Salt Spring Island Local Trust Committee

Regular Meeting Addendum

16.2. SS-DP-2018.14 - J. Verville, Kirsten Reite Architecture - 2661 and 2621 Fulford-Ganges Road, SSI (The Vortex)

Late changes to sewerage disposal fields - Staff Report

1. Sewage Disposal Field Siting Plan, drawn by IPR Trax Developments Ltd., dated August 5, 2022

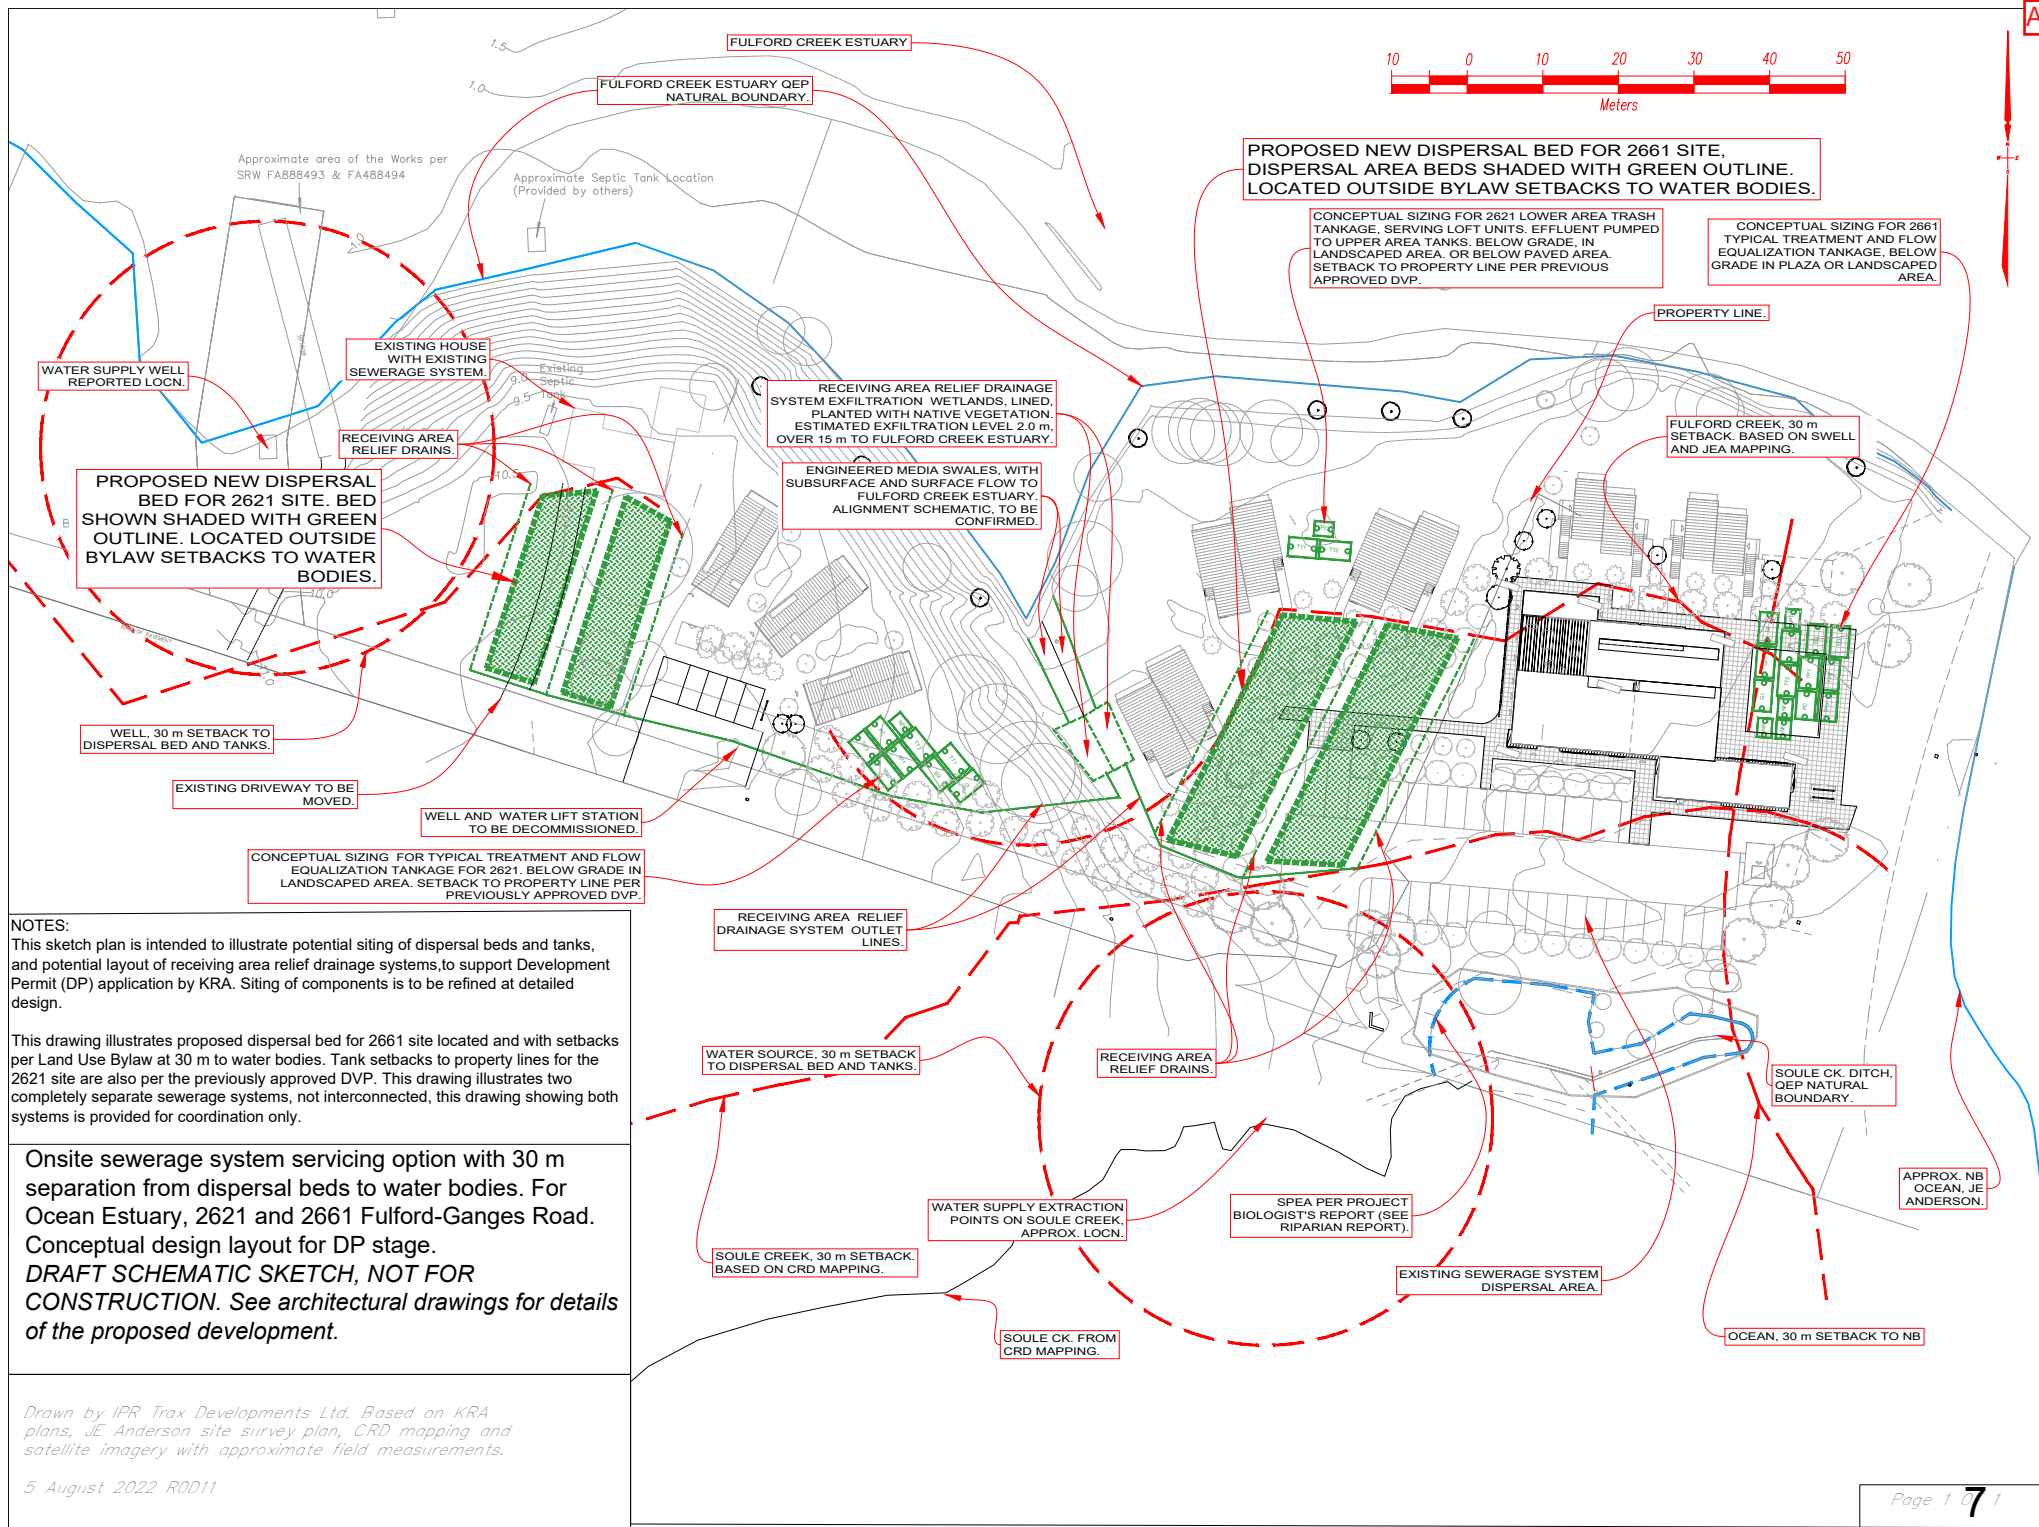
On August 5, 2022 the applicant for files SS-DVP-2021.24 and SS-DP-2018.14 submitted a revised sewage disposal site plan. This revised plan shows a proposed sewage disposal field for 2661 that is now located 30 metres from the natural boundary of Soule Creek, 30 metres from the Fulford Creek Estuary and 30 metres from the natural boundary of the sea in Fulford Harbour. The revised sewage disposal site plan is attached here as Appendix 1.

The revised sewage disposal site plan attached as Appendix 1 shows a sewage disposal field at 2661 Fulford-Ganges Road that will be located 30 metres beyond the natural boundary of Soule Creek, Fulford estuary, and Fulford Harbour. As such, the proposed sewage disposal field for this lot would no longer require a development variance permit to reduce the setback to waterbodies because the sewage disposal fields for the project would be bylaw compliant.

Regardless of the proposed relocation of the sewage disposal field, staff continue to advocate for the additional groundwater hydrology assessment and modeling identified in the staff report in the regular agenda package for the meeting of August 9, 2022. The resolution from that staff report is repeated here in the “Recommendations” section above.

- 1) *That the sewage disposal system site plan in Schedule No. 8 be replaced with the sewage system disposal system site plan shown in Appendix No. 1 of the staff report dated August 8, 2022;*

- 2) *That despite all references otherwise within the schedules to development permit SS-DP-2018.14, the sewage disposal field at 2661 Fulford Ganges Road will be sited in accordance with Appendix 1 of the staff report dated August 8, 2022;*

NOTES:
 This sketch plan is intended to illustrate potential siting of dispersal beds and tanks, and potential layout of receiving area relief drainage systems, to support Development Permit (DP) application by KRA. Siting of components is to be refined at detailed design.

This drawing illustrates proposed dispersal bed for 2661 site located and with setbacks per Land Use Bylaw at 30 m to water bodies. Tank setbacks to property lines for the 2621 site are also per the previously approved DVP. This drawing illustrates two completely separate sewerage systems, not interconnected, this drawing showing both systems is provided for coordination only.

Onsite sewerage system servicing option with 30 m separation from dispersal beds to water bodies. For Ocean Estuary, 2621 and 2661 Fulford-Ganges Road. Conceptual design layout for DP stage.
DRAFT SCHEMATIC SKETCH, NOT FOR CONSTRUCTION. See architectural drawings for details of the proposed development.
